DRB CASE ACTION LOG - BLUE SHEET

Project #: 1007488 Application #: 12DRB-7072
Project Name: Sisters of the Order of St. Dominic
Agent: DKKER Pouch Sabatini Phone #:

**Project #1007488 12DRB-70172 Amended Site Development Plan for Building Permit –
Lot(s) D-1E-1, Sisters of the Order of St. Dominic zoned SU-2/IP-EP**

Re: DRB Re-submittal to address comments from 6/20/2012 hearing
Request for Amended Site Development Plan for Building Permit
Project # 1007488; 12DRB-70172

SHEET NO. **A3C**

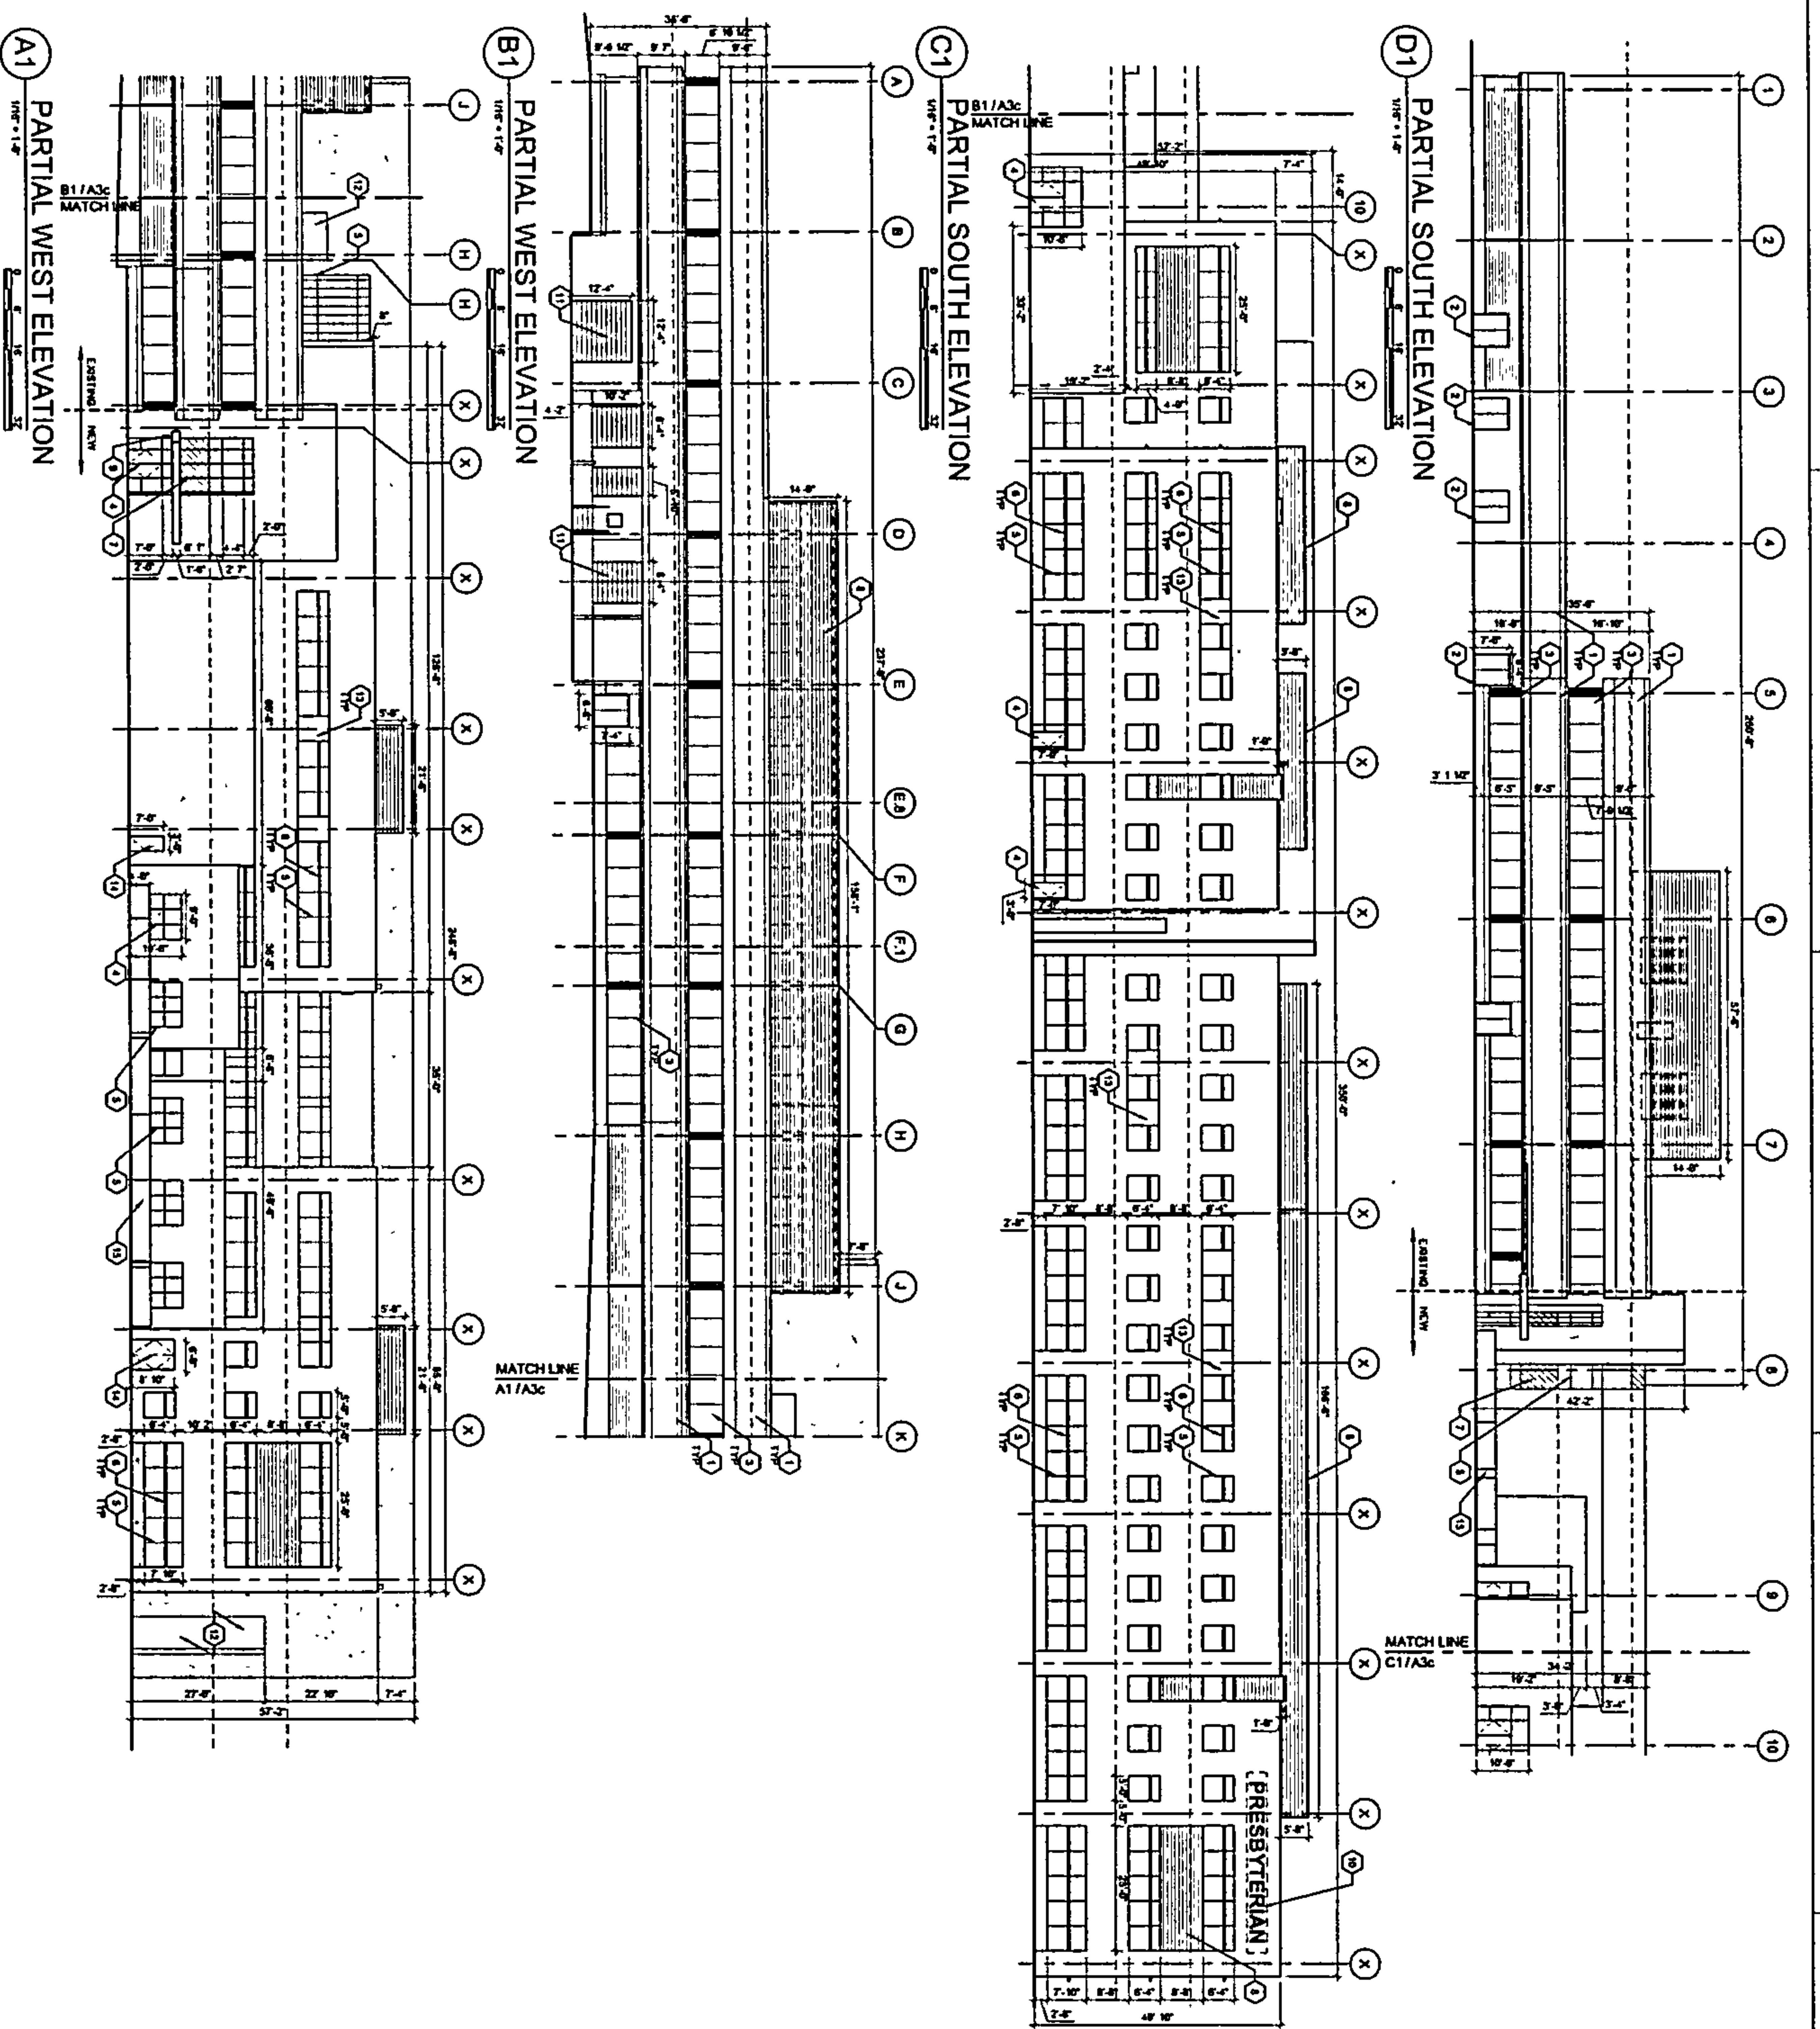
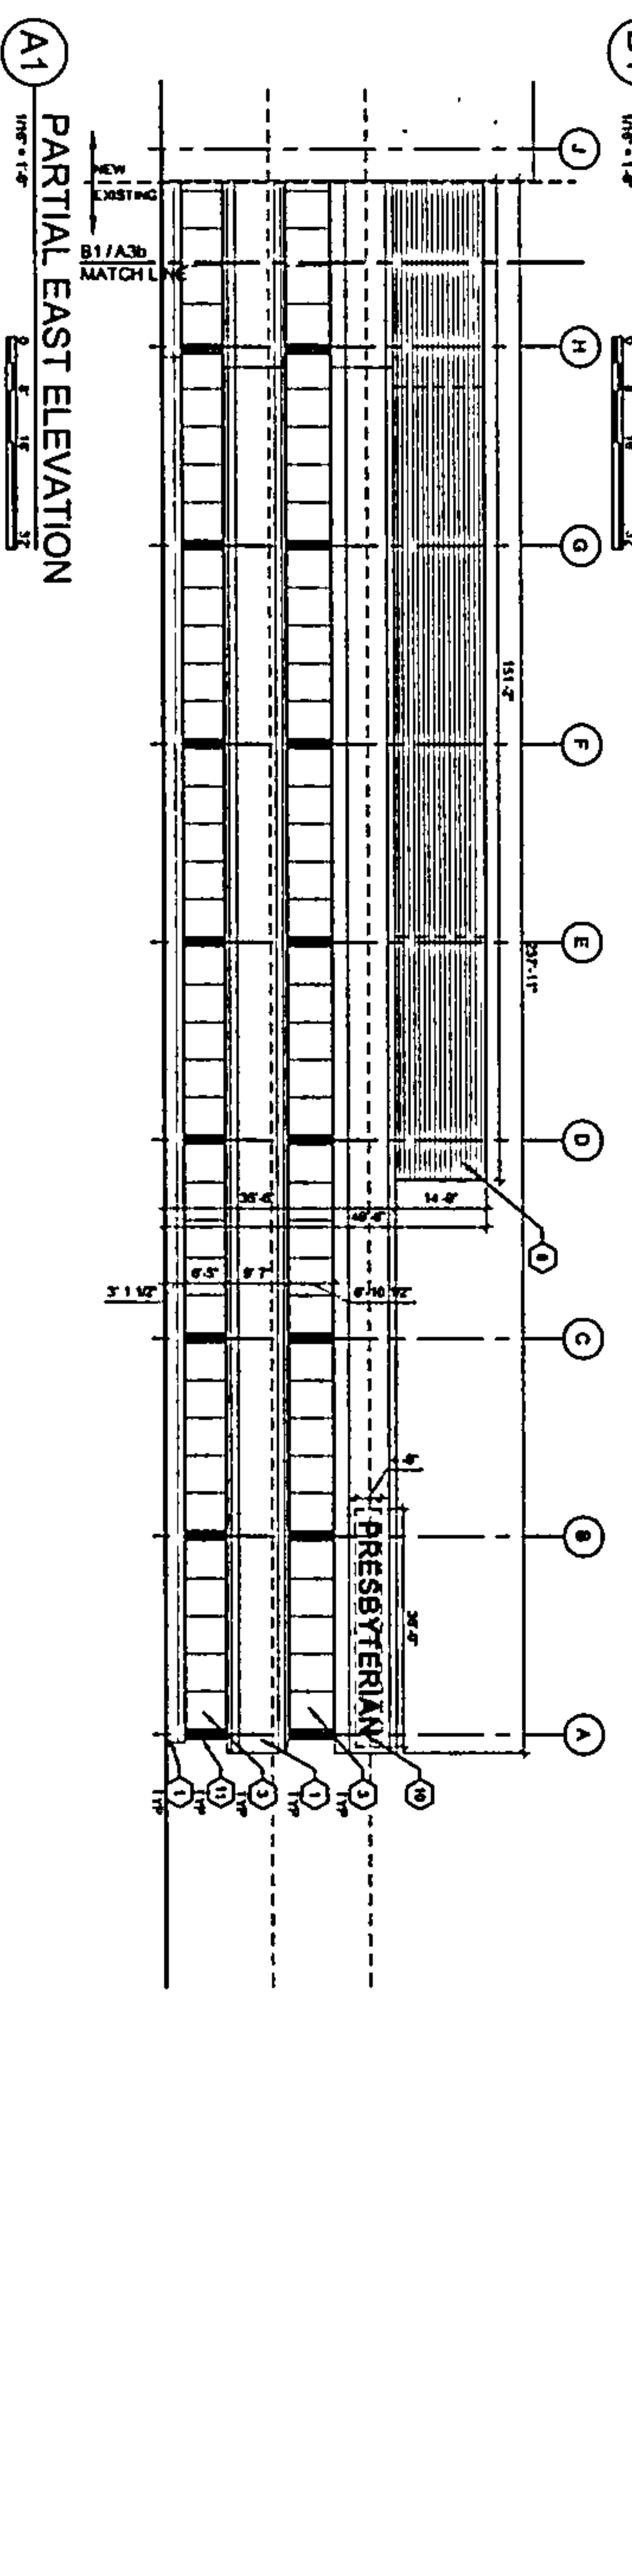
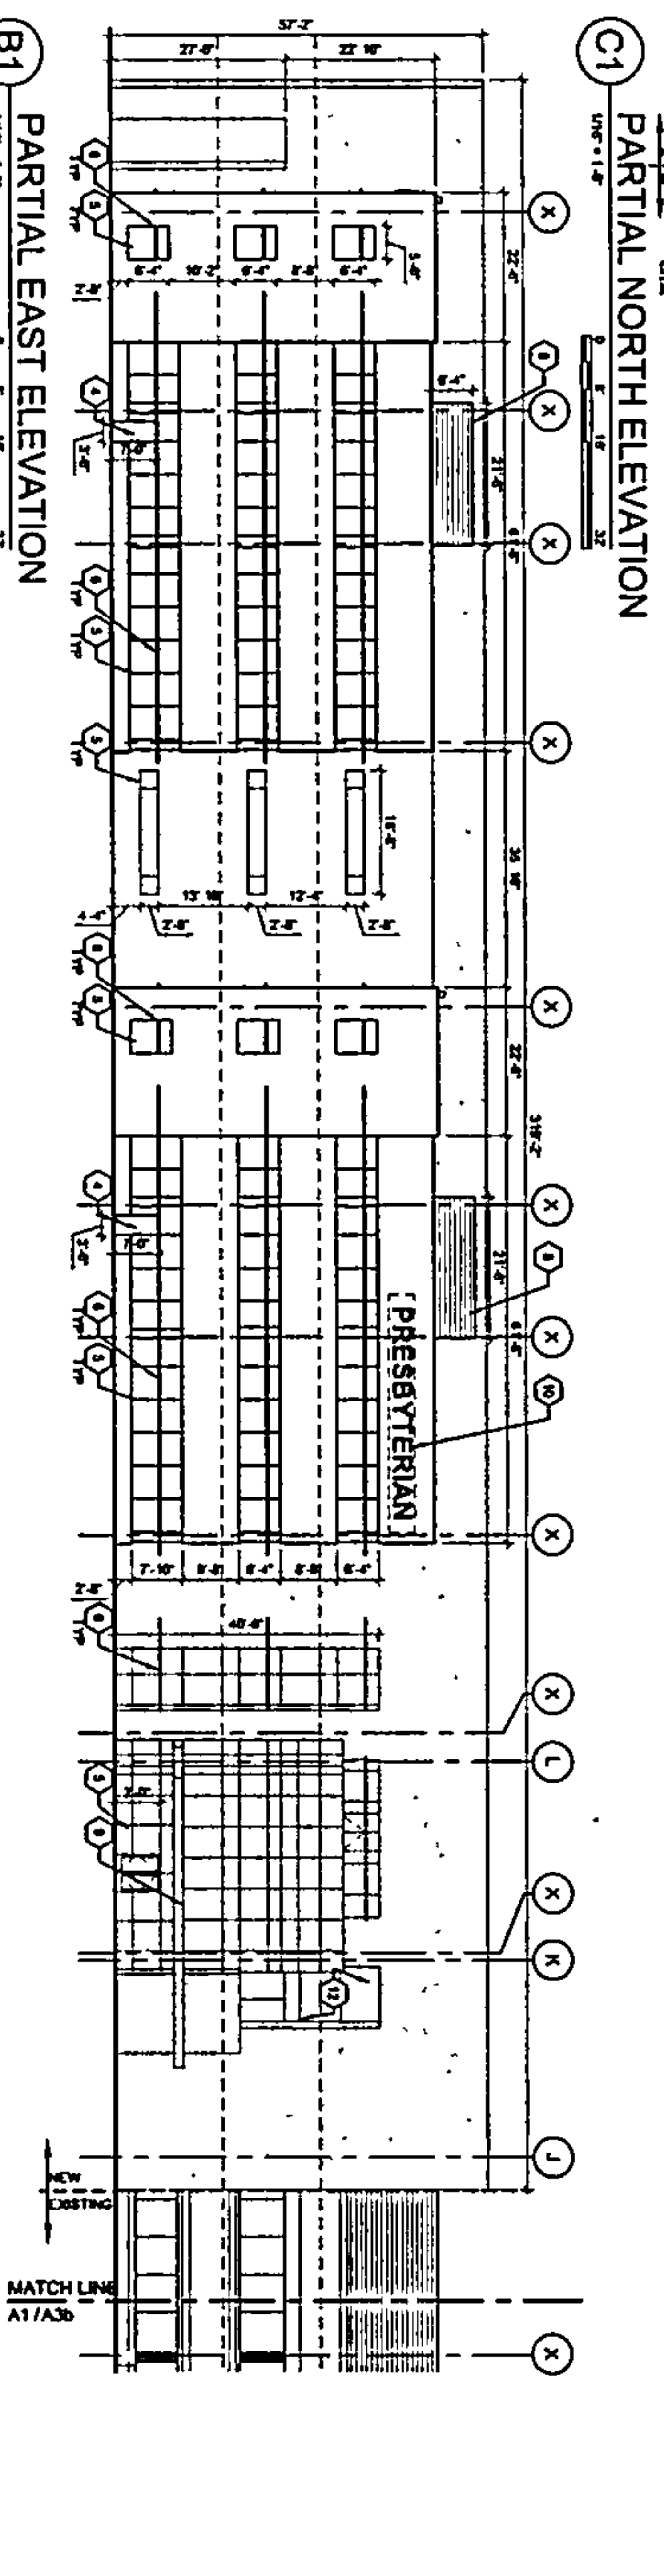
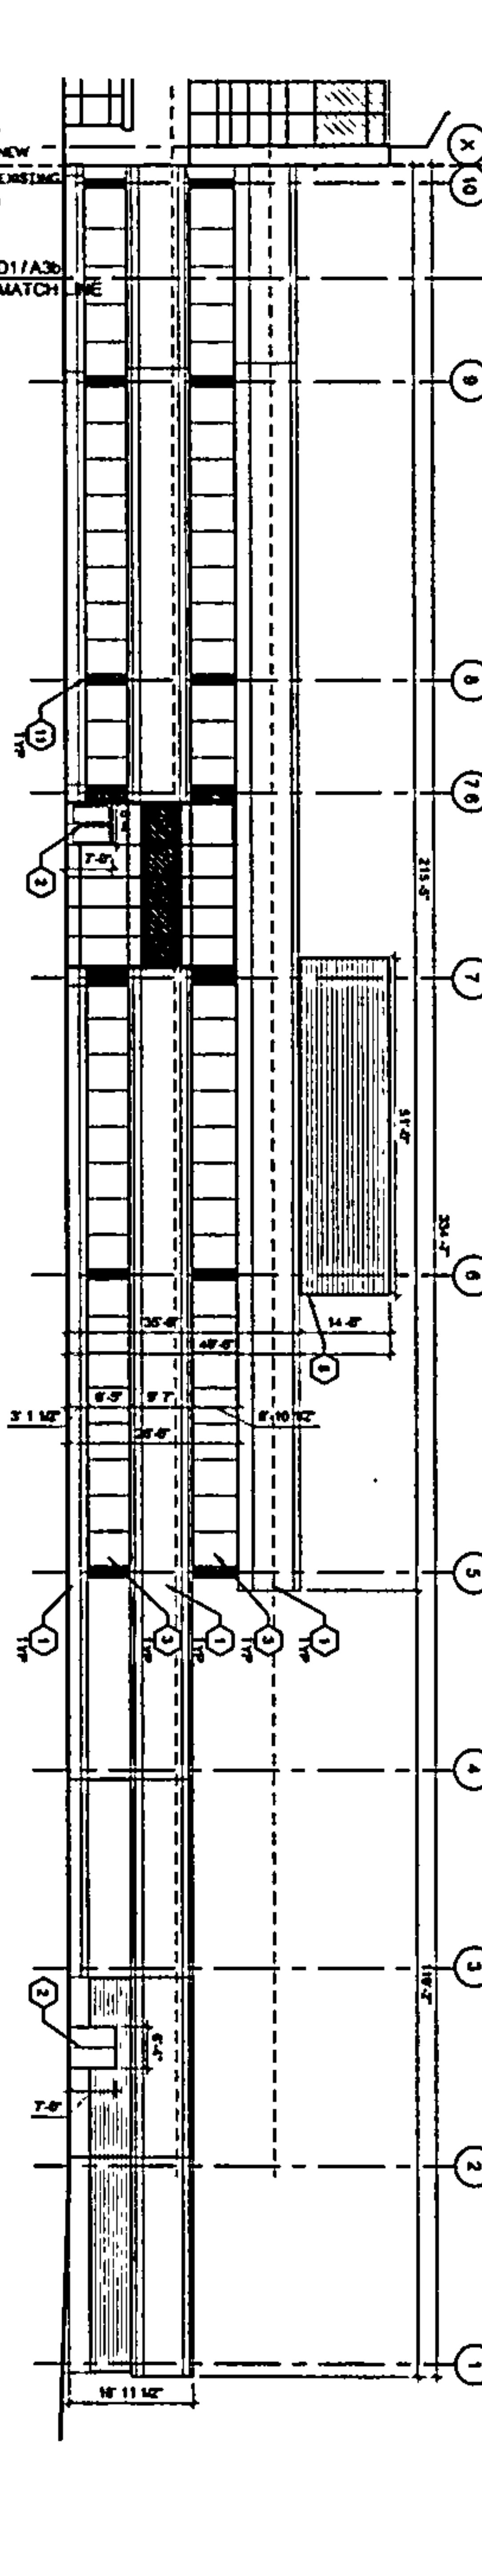
- 1. Height shown for new building is 57' 2" which exceeds the North I-25 Sector Development Plan 3 story height limit of 39' which is a concern for balloonists safety.**

- iv. Building sign letter size: the Site Development Plan elevations have been revised to limit the sign letter size to 18" per the Design Regulations.

- v. Building sign height: the Site Development Plan elevations have been revised to locate the building mounted signs between the second floor level and the first floor ceiling, per the Design Regulations.

- vi. Building height overlay: as noted above, we are following the existing zoning compliance path, which allows the building height per the requirements of the Zone Code, per section 4.3 of the Sector Plan.
